Re: Chevron Service Station # 9-1924

Re: **Revised Response to Comments**
Chevron Service Station 9-1924
4904 Southfront Road, Livermore, California
Fuel Leak Case No. RO0000477

On behalf of Chevron Environmental Management Company (Chevron), Cambria Environmental Technology, Inc. (Cambria) has prepared this letter report in response to the ACHCSA letter dated January 10, 2006 (Attachment A). The ACHCSA letter requested the following:

Figure 1
Zone 7 Well Survey Map

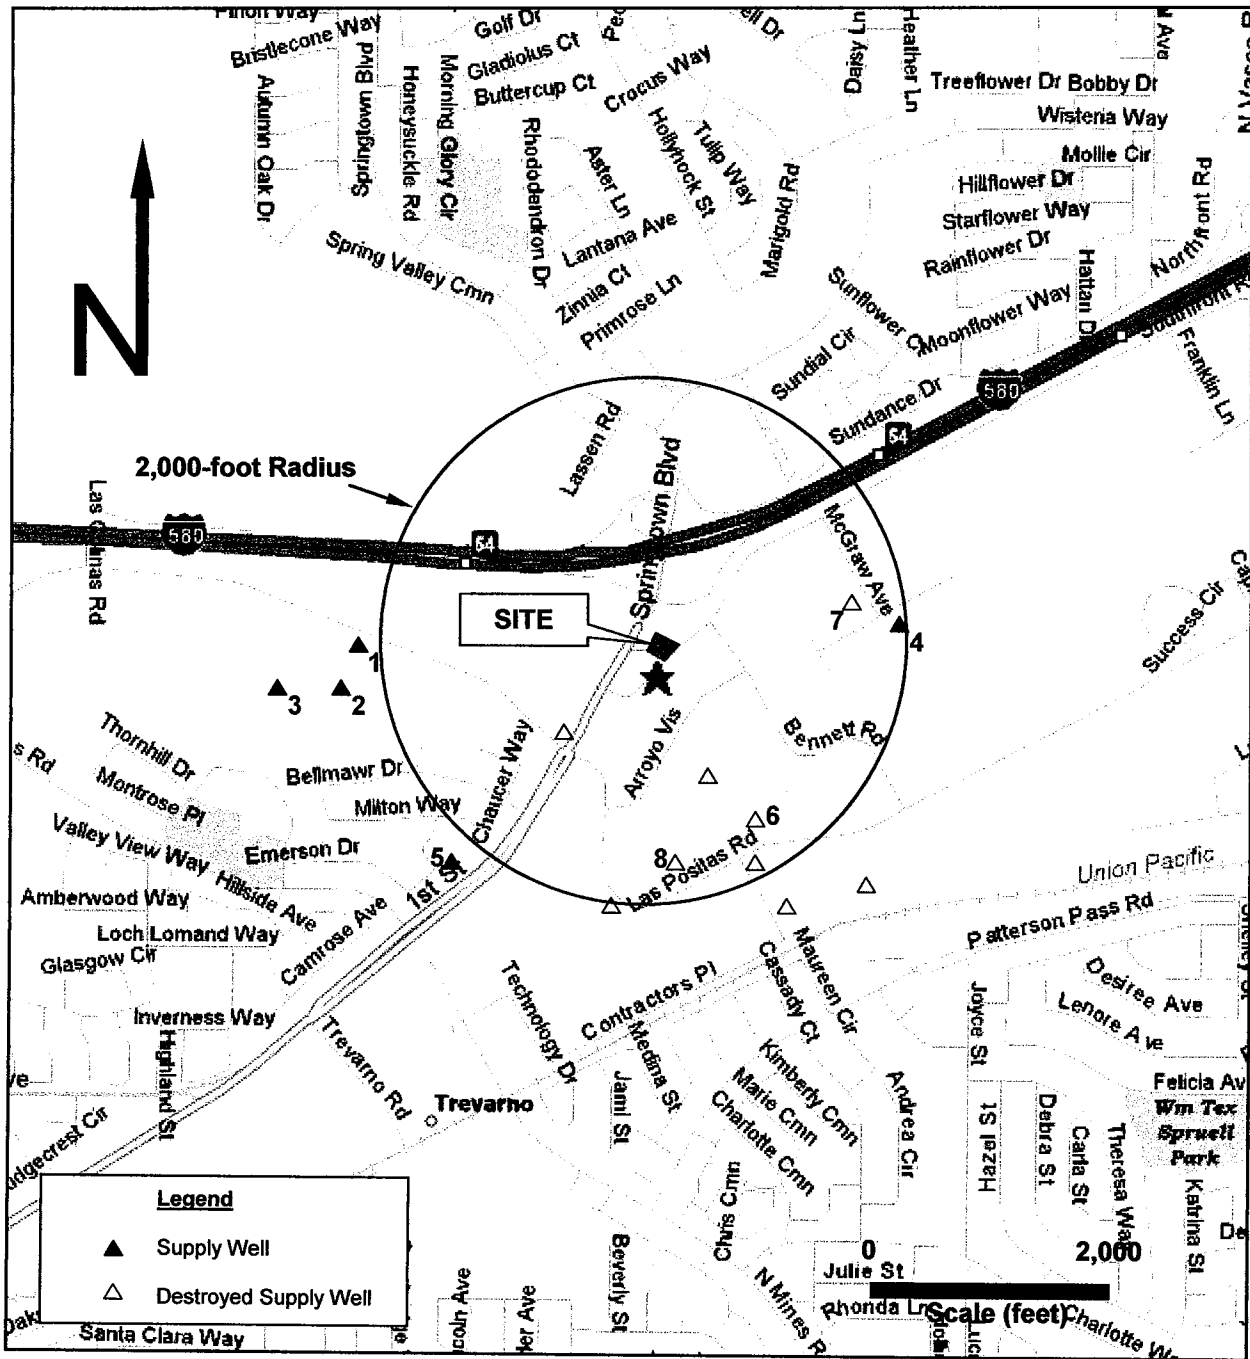
1. **Water Wells near the Site.** We requested that you also obtain well information from the Zone 7 Water Agency to confirm that no other water supply wells exist within 2,000 feet of the site and to confirm that irrigation and domestic wells identified by previous well surveys were destroyed. The location of a Zone 7 water-producing well approximately 1.5 miles

south of the site as shown on a generalized map was discussed but no further information on the construction of known wells or confirmation that no other wells exist in the local area was provided. The purpose of this information is to help assess potential risks if the plume extends deeper than currently presumed. Please see the discussion in comment 3 regarding the vertical extent of contamination.

On March 27, 2006, Cambria reviewed files at the Zone 7 Water Agency (Zone 7). Cambria identified six existing and nine former water supply wells in the vicinity of the site, and obtained well log and construction information for nine of the wells including the existing wells. Of the six existing wells, only one well, an irrigation well owned by PG&E, is located within 2,000 feet of the site. The PG&E well, located at the Las Positas Sub Station at 5179 Preston Avenue, is upgradient of the site. Figure 1 shows the locations of the nearby water supply wells, and Table 1 summarized information on the wells obtained from Zone 7. Available well log and construction information obtained from Zone 7 is included in Attachment B.

FIGURE
2

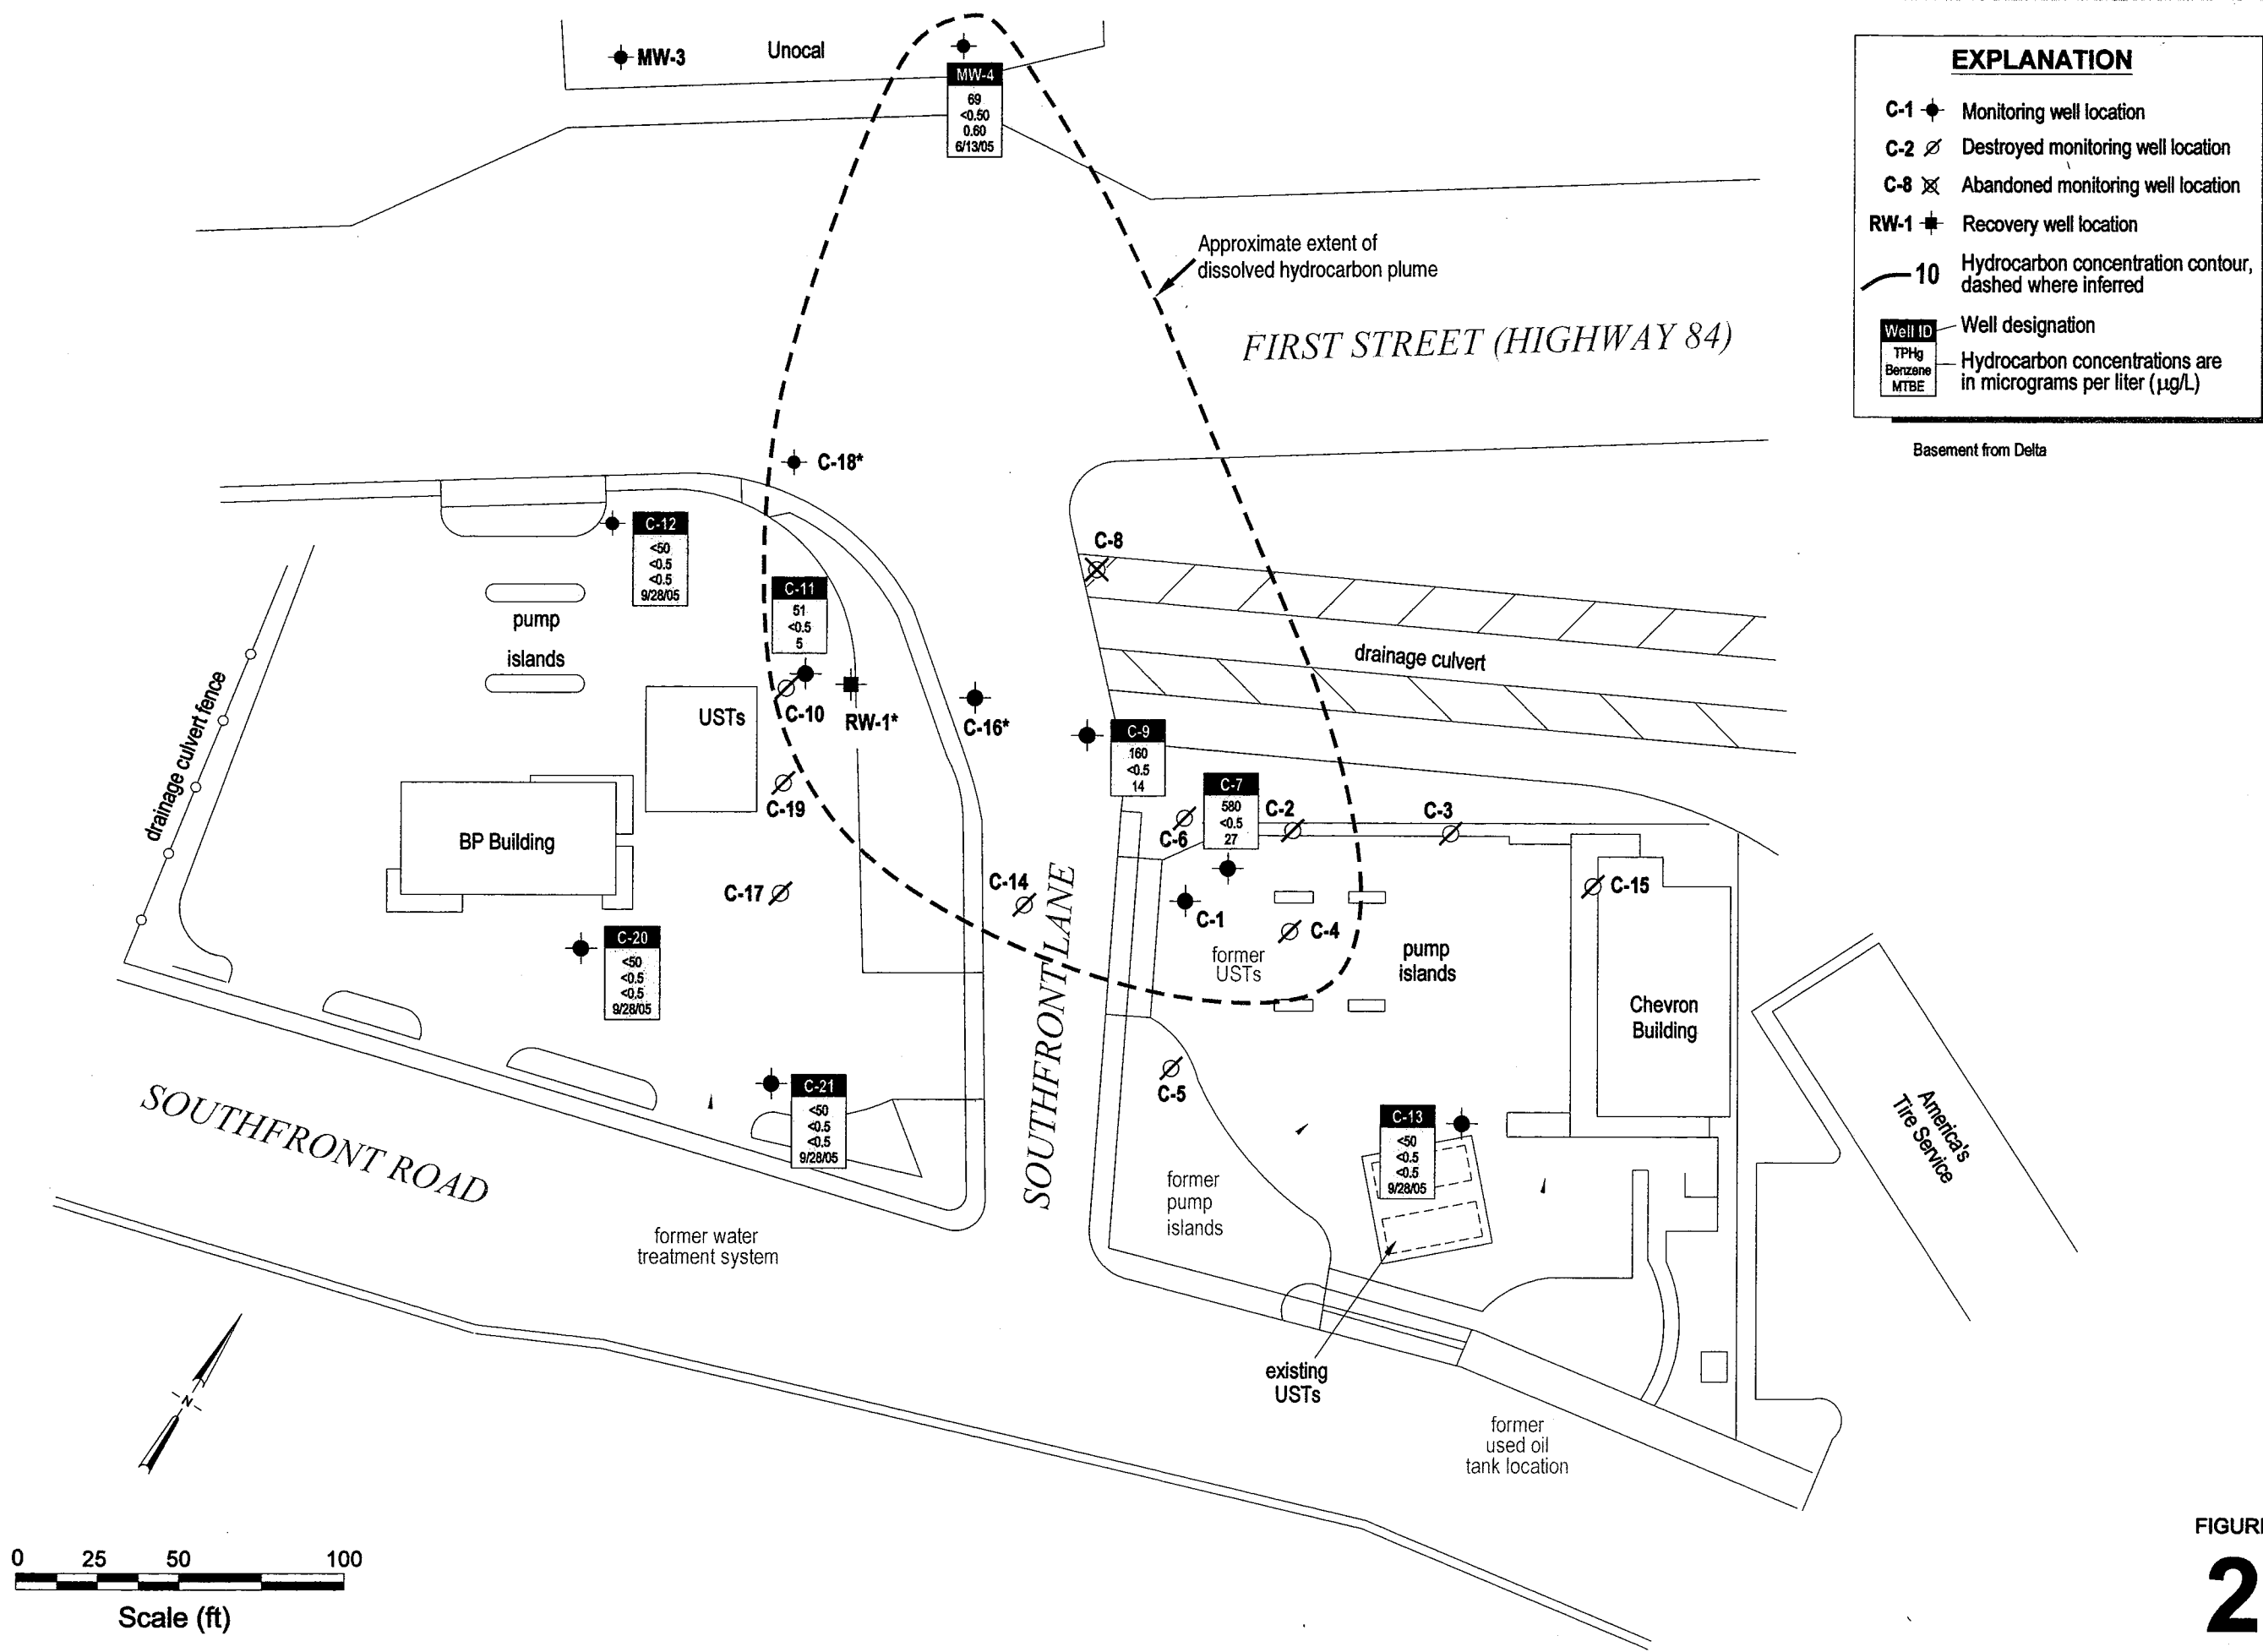
- 2) Revise Figure 2 from Cambria's November 23, 2005, *Response to Comments* to include nearby Unocal wells and revised extent of groundwater impact.**

2. **Horizontal Extent of Plume in Shallow Groundwater.** We concur that TPHg and MTBE concentrations in shallow groundwater are decreasing over time and that the shallow groundwater plumes at the site appear to be shrinking. However, the approximate extents of the TPHg and MTBE plumes shown on Figure 2 most likely underestimate the extent of the shallow groundwater contamination. Historical potentiometric surface maps constructed using data collected jointly from monitoring wells at the Unocal station at 4700 First Street, Chevron station at 4904 Front Street, and the ARCO station on the west side of Southfront Road indicate that the Unocal station at 4700 First Street is downgradient of the Chevron Station at 4904 Southfront Road. Monitoring well MW-4, which is on the southeast boundary of the Unocal station property, is upgradient from sources at the Unocal station but is downgradient from the Chevron station. Dissolved fuel hydrocarbons have consistently been detected in this well since monitoring began in 1989. During the most recently reported groundwater monitoring event, TPHg was detected at a concentration of 69 micrograms per liter ($\mu\text{g/L}$) and MTBE was detected at 0.6 $\mu\text{g/L}$. Therefore, the extent of the TPHg and MTBE plume from the Chevron site is larger than shown on Figure 2. Please revise Figure 2 accordingly.

Revised map is attached as Figure 2.

Figure 3 - Subsurface Stratigraphy
Chevron Service Station 9-1924, 4904 Southfront Road, Livermore, California

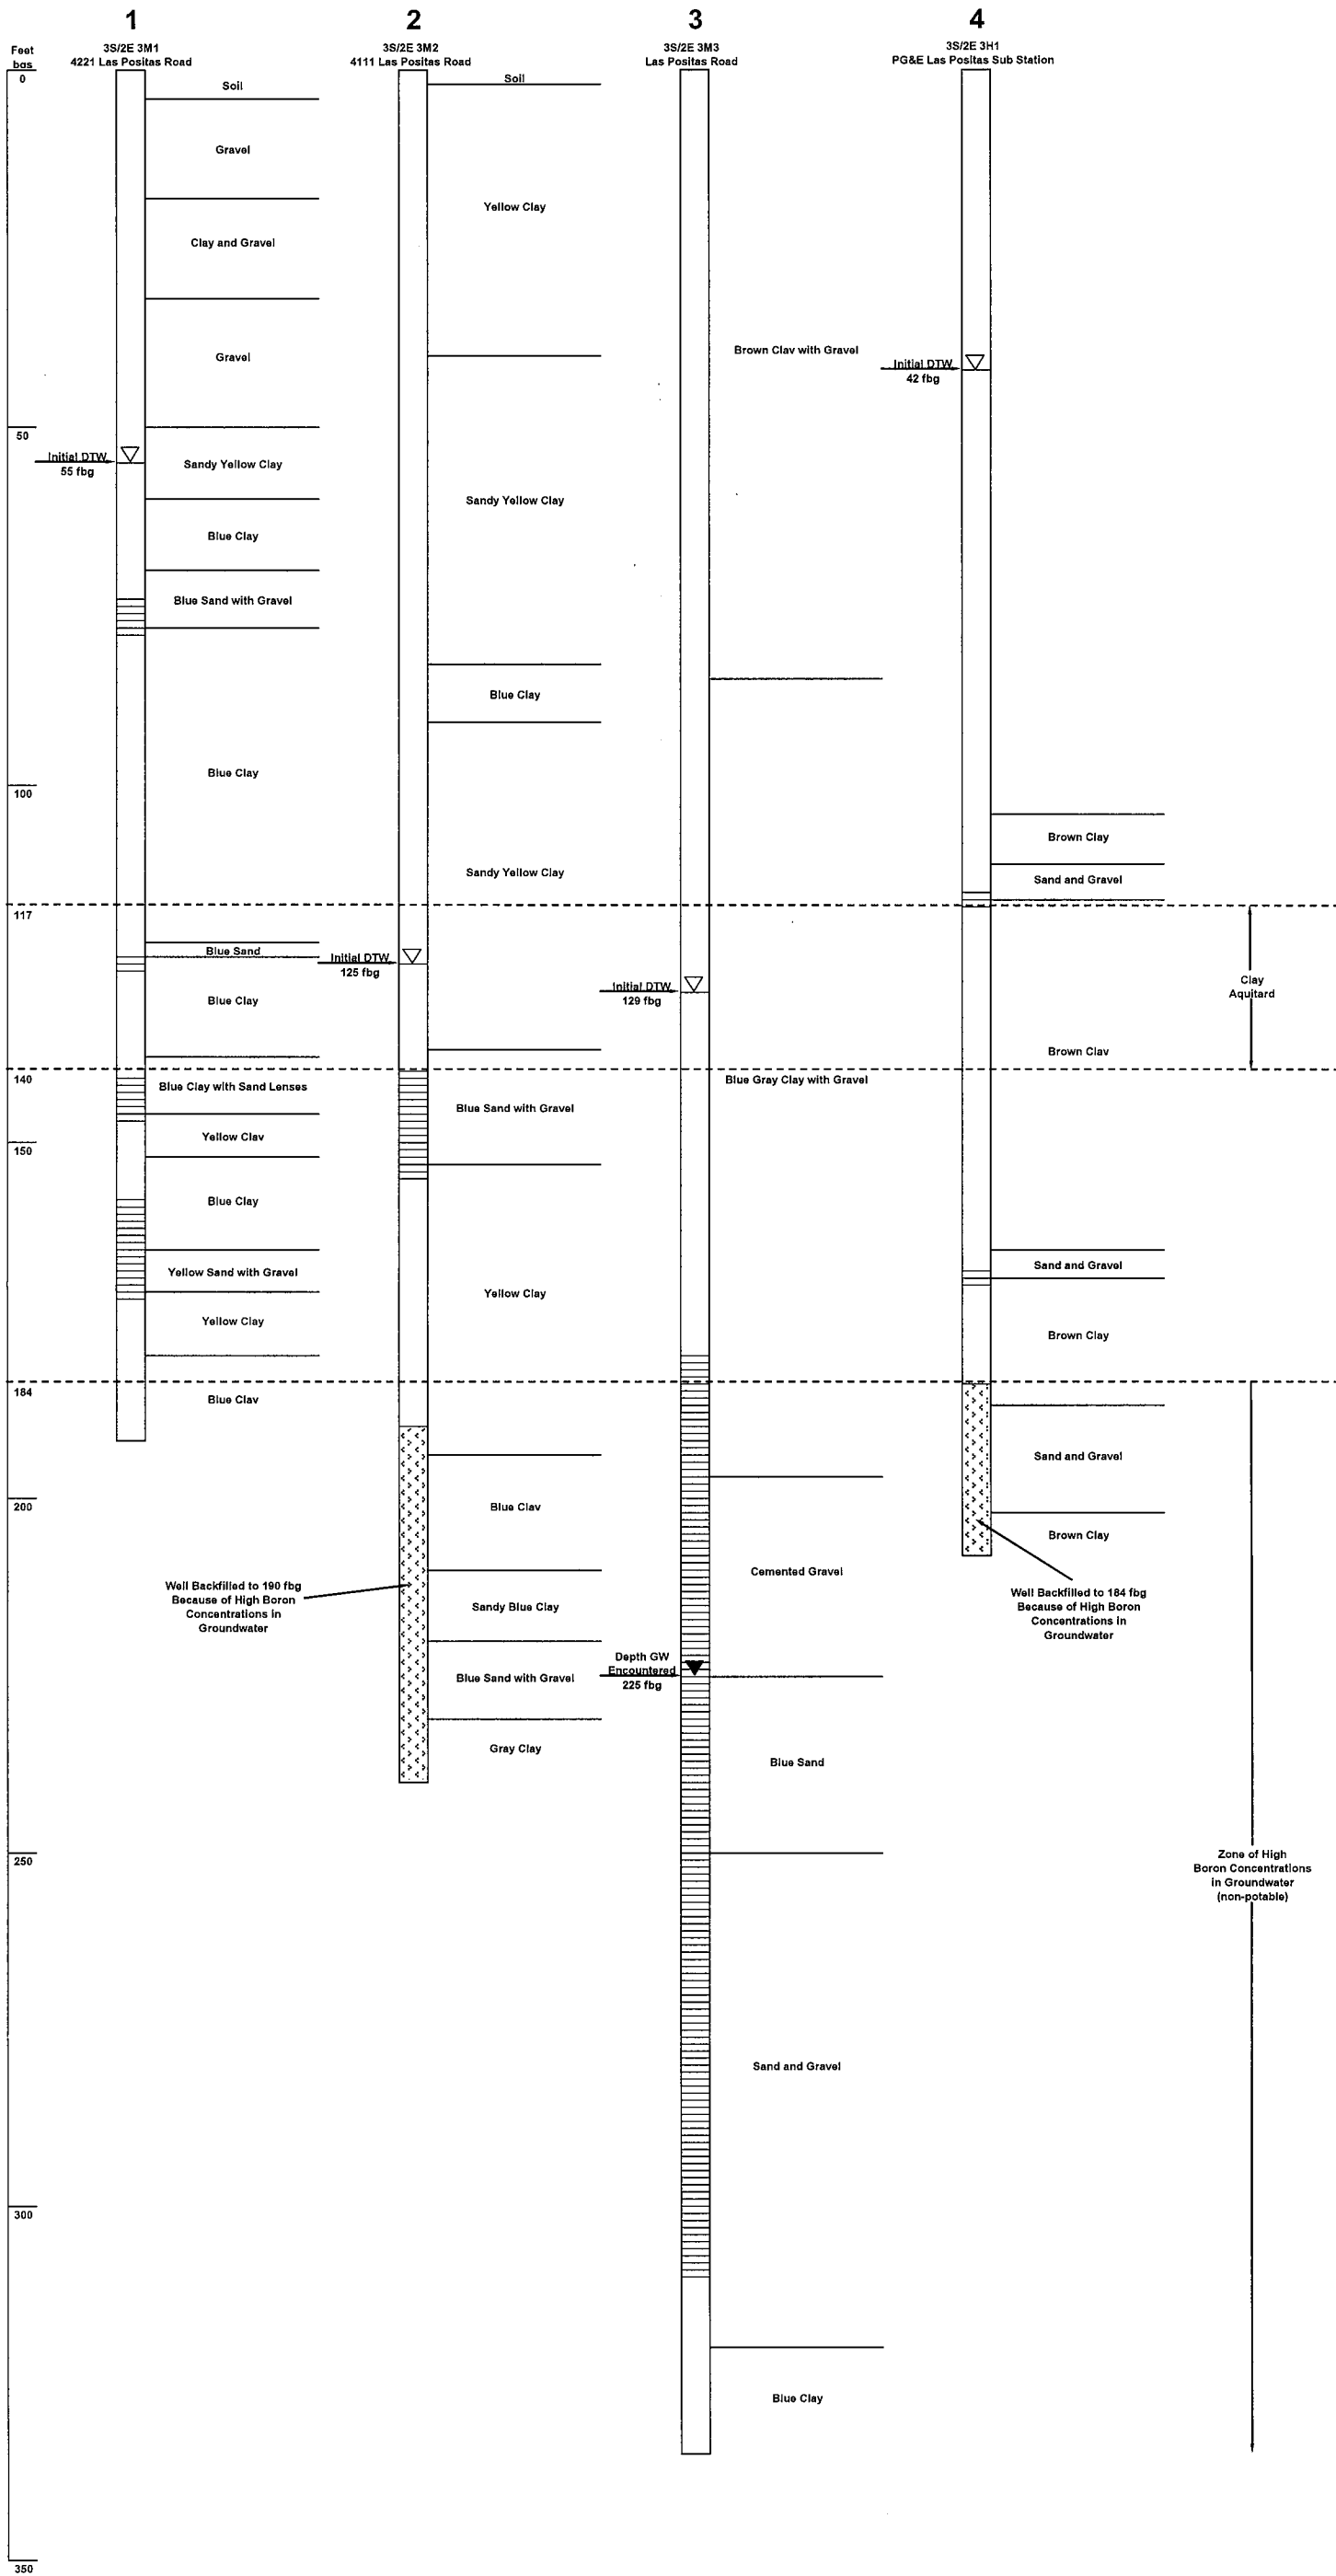
3) **Discuss the potential impact to deeper water bearing zones from dissolved fuel hydrocarbons at the subject site.**

3. **Impact to Lower Water-Bearing Zones.** Due to the fact that no soil or groundwater samples have been collected below 30 feet bgs at the site, we requested that the potential for impact to lower water-bearing zones be discussed using, but not limited to, additional information on the stratigraphy, depth to water-bearing zones, likely vertical gradients, history of fuel releases, and historic water level fluctuations. We also suggested that a nearby Zone 7 monitoring well located in close proximity to the site may be a source of useful information to help address the above items, particularly historic groundwater fluctuations. Broad regional information was discussed but no site-specific information, local data on the depth to water-bearing zones, likely vertical gradients, history of releases at the site, or historic water level fluctuations was presented in the November 23, 2005 "Response to Comments." The response concludes by assuming that the plume is shrinking and is of limited extent; therefore, potential impact to lower water-bearing zones is unlikely.

One of the reasons that we requested local information on the depth to water-bearing zones, likely vertical gradients, history of releases at the site, and historic water level fluctuations is to assess whether the observed decreases in concentrations are related to natural attenuation within shallow groundwater or whether the decreases are due to downward migration of fuel hydrocarbons below the depth of the existing monitoring wells. The potential for vertical gradients and downward migration of contaminants is not addressed or considered in the Response to Comments. Information on historic releases and historic groundwater fluctuations was requested in order to assess whether releases at the site may have occurred during periods of lower groundwater levels. In such cases, fuel hydrocarbons would migrate below current groundwater levels and below the zone of current groundwater monitoring to lower water-bearing zones. The potential for releases to have occurred during periods of lower water level and to have impacted lower water-bearing zones is also not considered in the Response to Comments. Therefore, we request that you evaluate potential

impacts to lower water-bearing zones by considering factors beyond presumptions that are based solely on concentration trends in the existing monitoring wells.

Figure 3 presents subsurface stratigraphic information from four of the existing water supply wells in the vicinity of the site. As shown on Figure 3, the subsurface in the vicinity of the site consists mostly of clay with minor saturated, discontinuous horizons of sand and gravel to approximately 200 feet below grade (fbg), where sand and gravel become more prominent. Based on known depth to groundwater data, there appears to be at least four distinct water bearing zones beneath the site. Historically, groundwater in monitoring wells on-site has fluctuated between approximately 10 to 15 fbg. This suggests that shallow groundwater beneath the site may represent a perched zone. On Figure 3, the wells #1 and #4 with screened intervals above 117 fbg, within narrow sand and gravel horizons, had initial water in the wells at 55 and 42 fbg, respectively. These narrow sand and gravel horizons appear to represent a second, discontinuous water bearing zone beneath the shallow perched zone at the site. Other wells included in Table 1, specifically #7 and #8, support this second, discontinuous water bearing zone. With the significant clay content of this second zone, it is unlikely that significant vertical migration of impact occurs from the shallow perched zone. Wells #2 and #3 in Figure 3 show initial water levels in the wells at 125 and 129 fbg, respectively. Based on screen intervals, this appears to represent a third, distinct water bearing zone. This third zone suggests that the clay present between approximately 117 to 140 fbg acts as an aquitard. In wells #2, #3, and #4 there appears to be a fourth water bearing zone below approximately 184 fbg. This fourth zone is distinct in that it is non-potable due to high boron concentrations. Both wells #2 and #4 were filled with cement to approximately 190 and 184 fbg, respectively, to seal off this lower boron impacted zone. Water from the third zone does not have this high boron content, so there appears to be a distinct separation of the third and fourth zones.
